Access Compliance Report

Public Rights-of-Way

Intersection ID: 29147	Main Street: BALSAM_TREE_DR	Cross Street: WALLACE_RIDGE_DR	Location: SE
ADA ID: CE0A39492DF0	Ramp Type: BlendTrans1	Initial Pass/Fail: Fail	Overall Compliance: No
		Severity Score: 25

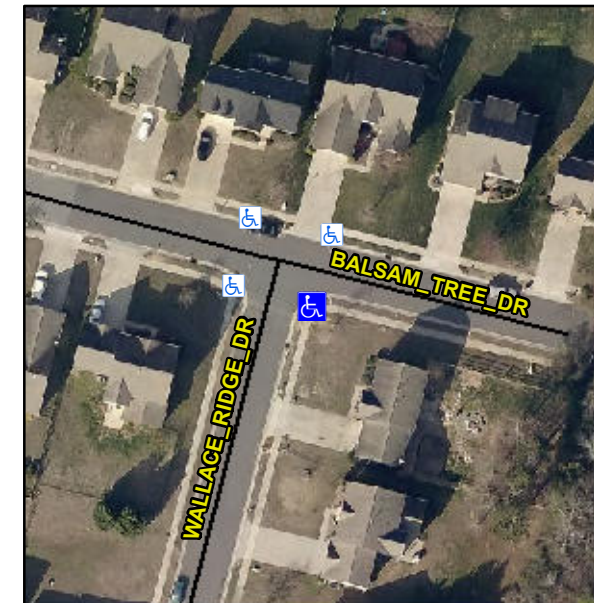
Not Found, R304.5.3

Compliance	Description	Data	Compliance	Description	Data
N/A	Ramp Length (in)	48.0	Yes	BlendTrans Slope (%)	3.8
Yes	Ramp Width (in)	144.0	No	BlendTrans XSlope (%)	8.3
N/A	Flare Type LT	N/A	N/A	Flare Type RT	N/A
N/A	Flare Slope LT (%)	N/A	N/A	Flare Slope RT (%)	N/A
N/A	Flare Traversable LT?	N/A	N/A	Flare Traversable RT?	N/A
N/A	Landing Length (in)	N/A	N/A	DWS Provided?	N/A
N/A	Landing Width (in)	N/A	N/A	DWS Contrast?	N/A
N/A	Landing Slope (%)	N/A	N/A	DWS Length (in)	N/A
N/A	Landing X Slope (%)	N/A	N/A	DWS Full Width?	N/A
N/A	Landing Curb? (Y/N)	N/A	N/A	DWS Offset (in)	N/A
N/A	Shared Landing?	N/A			
N/A	Gutter Ponding?	N/A	N/A	Gutter Slope (%)	N/A
N/A	Gutter Lip Ht (in)	N/A	N/A	Gutter X Slope (%)	N/A
N/A	Painted X Walk1?	No	N/A	Painted X Walk2?	No
	X Walk 1 Direction	To N		X Walk 2 Direction	To NW
	X Walk 1 Width (in)	N/A		X Walk 2 Width (in)	N/A
	X Walk 1 Slope (%)	1.4		X Walk 2 Slope (%)	6.9
	X Walk 1 X Slope (%)	8.5		X Walk 2 X Slope (%)	0.3

Remove & Replace Curb Ramp With Two New Directional Ramps or Equivalent.
